SYDNEY METRO VICTORIA CROSS OVER STATION DEVELOPMENT SSDA

**NORTH SYDNEY COUNCIL SUBMISSION
SYDNEY METRO VICTORIA CROSS OVER STATION DEVELOPMENT SSDA
(REF # SSD_8874)**

Source: Concept State Significant Development Application EIS

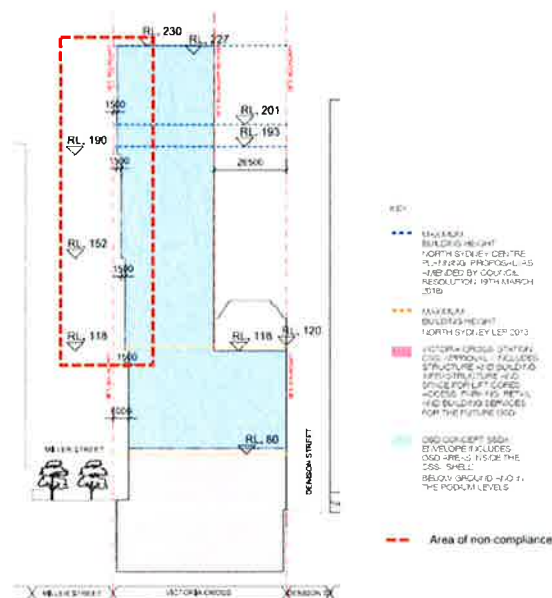
Up to a height of RL 118, the proposed building envelope is set back in accordance with the setback shown on the North Sydney Centre Map. At RL 118 and above, the envelope includes a reduced setback. The setback reduces (or step towards the street) in 1.5m increments at three heights (RL 118, RL 152 and RL 190), with a minimum setback of 1.5m at the top section of the envelope. The effect is to split the envelope into four separate volumes. Refer to the south elevation of the envelope below.

The stepping setback results in the following non-compliances with the Miller Street setback standard: – Between RL 118 and RL 152, the maximum non-compliance is 1.5m (or 13% at the irregular extension of the frontage and 25% at the remainder of the frontage). – Between RL 152 and RL 190, the maximum non-compliance 3m (or 25% at the irregular extension of the frontage and 50% at the remainder of the frontage). – At RL 190 and above, the maximum non-compliance is 4.5m (or 39% at the irregular extension of the frontage and 75% at the remainder of the frontage).

The Clause 4.6 objection is not supported. It fails to address the other development standard in the Clause being “the building height will be less than 1.5 metres”. The building height is significantly higher than the 1.5m permitted within the setback. Council’s character statement for the CBD recommends buildings with podiums and towers setback from the podium edge. The proposed tower is inconsistent with existing surrounding development as well as the future desired character. The building envelope would be out of context with all other buildings in the CBD and along Miller Street. The required setback should be observed for the full height of the tower, as is the case with the Berry Street setback.

2. ***That the DA be amended to comply absolutely with the Miller Street setback for the entirety of the façade of the building which faces Miller Street.***
